Item ID: D3016-3 Accept ***N900040100*** Setup Start ***NS1***
 Revision ID: Stop ***NS2***
 Item Name: Tube
 Start Date: 1/5/2017 Start Qty: 10.00 ***10*** Cust Item ID:
 Required Date: 1/5/2017 Req'd Qty: 10.00 ***10*** Customer:
 Reference:

DESIGN <i>CP</i>	DRAWN BY <i>CP</i>	DART AEROSPACE LTD HAWKESBURY, ONTARIO, CANADA	
CHECKED <i>#</i>	APPROVED <i>#</i>	DRAWING NO. D3016	REV. A SHEET 1 OF 3
DATE 01.05.18		TITLE SEAT FRAME ASSEMBLY	SCALE NTS
A	01.05.18	NEW ISSUE

DRAWING NO. D3016	TITLE SEAT FRAME ASSEMBLY	REV. A	DART AEROSPACE LTD ENGINEERING ORDER	D.E.O. NO. D3016-A-1	SHEET NO. SHEET 1 OF 1	SCALE NTS
DRAWN 1	CHECKED UP	MFG. APPR. BE	APPROVED WAP	DE APPR. WAP		
DATE 10.01.29	DATE 10.01.29	DATE 10.01.29	DATE 10.01.29	DATE 10.01.29

TO REVISE D3016-11 SADDLE'S HOLE SIZES

D3016-11 SADDLE

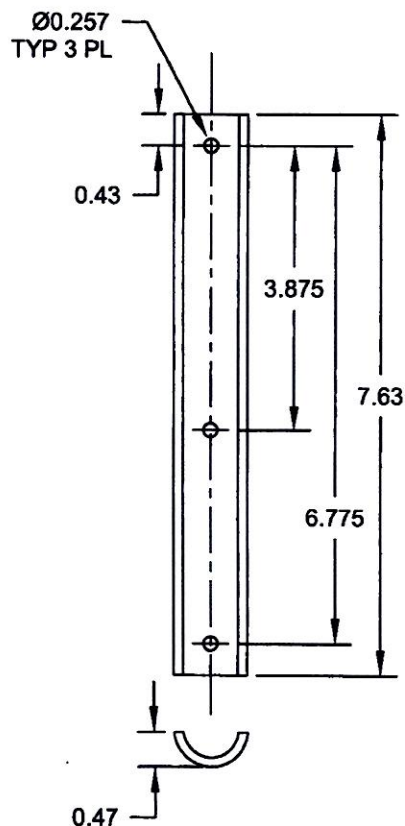
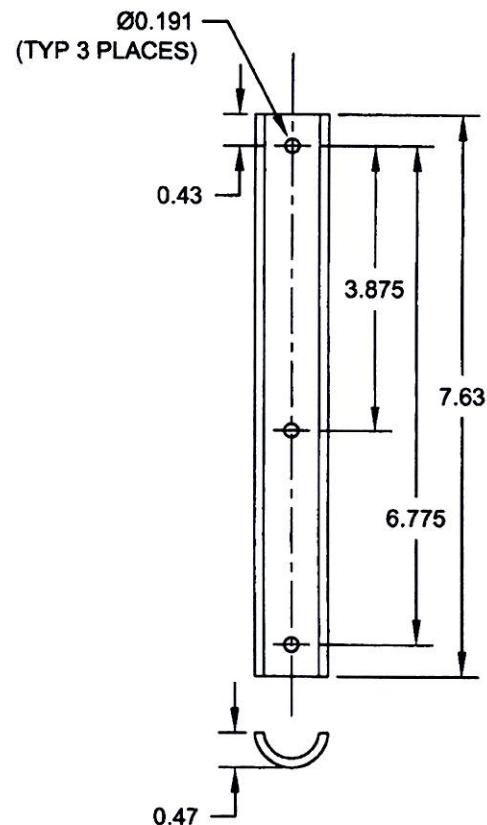
DETAIL D3016-11 SADDLE (SHEET 3): Ø0.257 TYP 3 PL WAS Ø0.191 (TYP 3 PLACES) AS SHOWN:
